SERVICE BULLETIN

NACELLE - EXHAUST - INSTALLATION OF HOIST POINT BLANKS (SETSCEWS) - CATEGORY CODE 4 -
MOD.NAC-78-0006

V2500-NAC-78-0006

Installation of Hoist Point Blanks
Fig.1

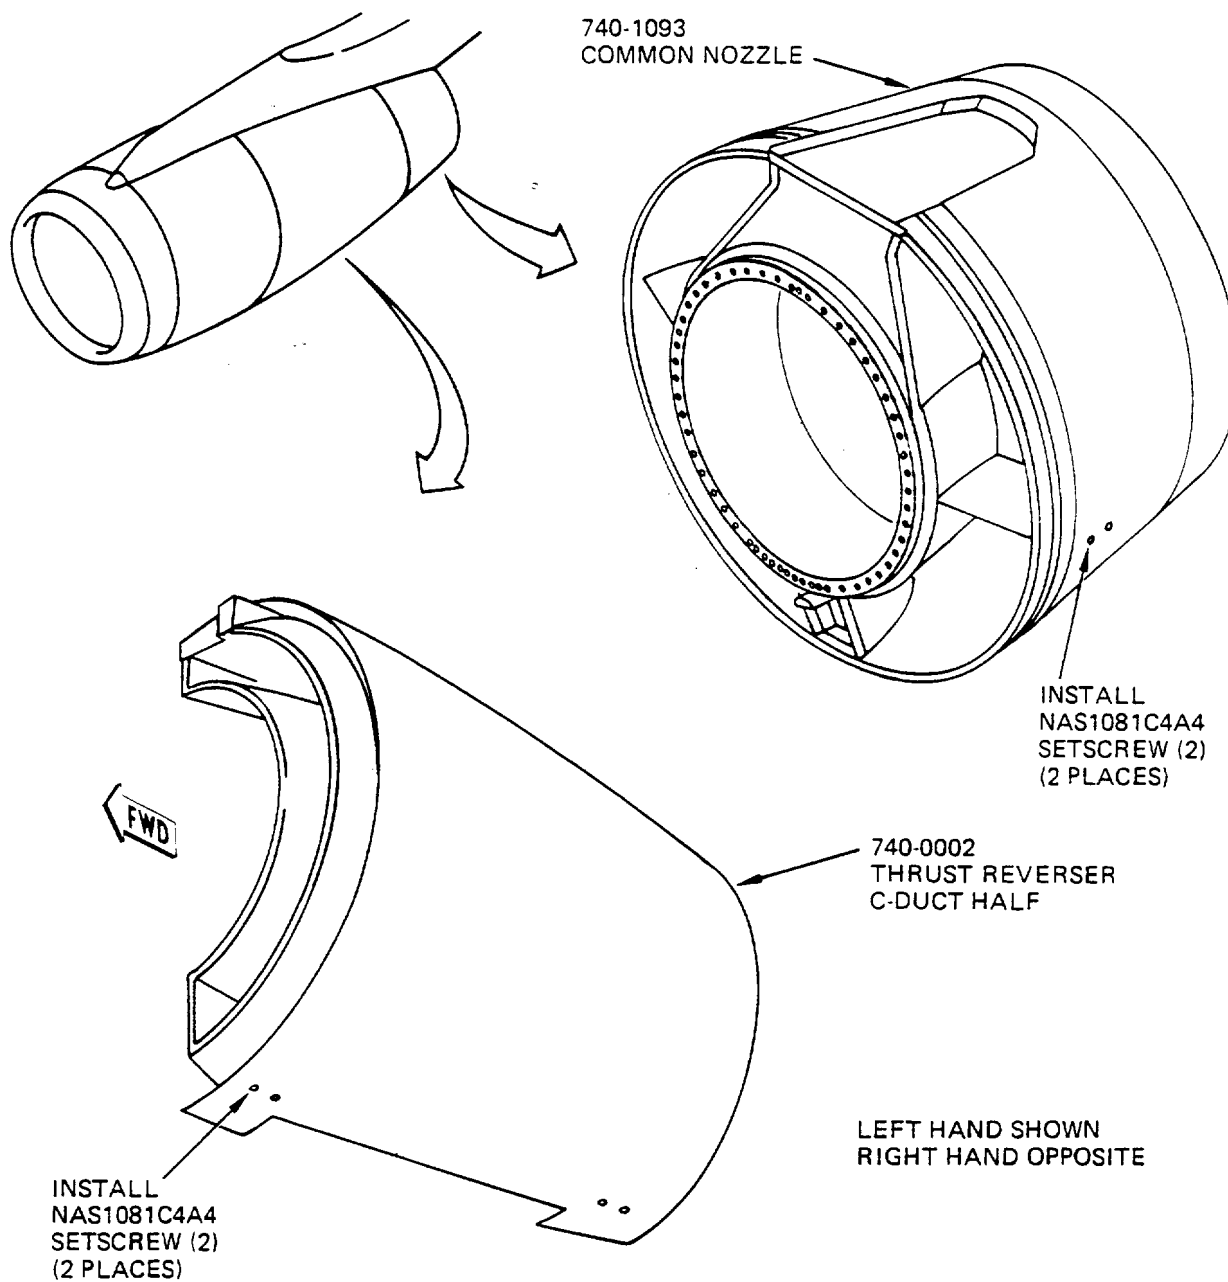
- (1) Find the 740-0002 Thrust Reverser and 740-1093 Common Nozzle. (Refer to Figure 1.)

- (1) Check four hoist points in 740-0002 thrust reverser L.H. C-duct lower edge for any signs of dirt.

- (2) Clean out any dirt in hoist points with a cleaner made moist with methyl isobutyl ketone (MIBK) and wipe dry before solvent becomes dry.
- (3) Install NAS1081CA4 setscrew in each hoist point and turn down until head of setscrew is aligned with outer surface of hoist point.
- (4) Check four hoist points in 740-0002 thrust reverser R.H. C-duct lower edge for any signs of dirt and do paragraphs 2.B.(2) and 2.B.(3).
- (5) Check two hoist points in both sides of 740-1093 common nozzle along centerline for any dirt.
- (6) Clean out dirt in hoist with a cleaner made moist with methyl isobutyl ketone (MIBK) and wipe dry solvent becomes dry.
- (7) Install NAS1081C4A4 setscrew in each hoist point and turn down until head of setscrew is aligned with outer surface of hoist point.
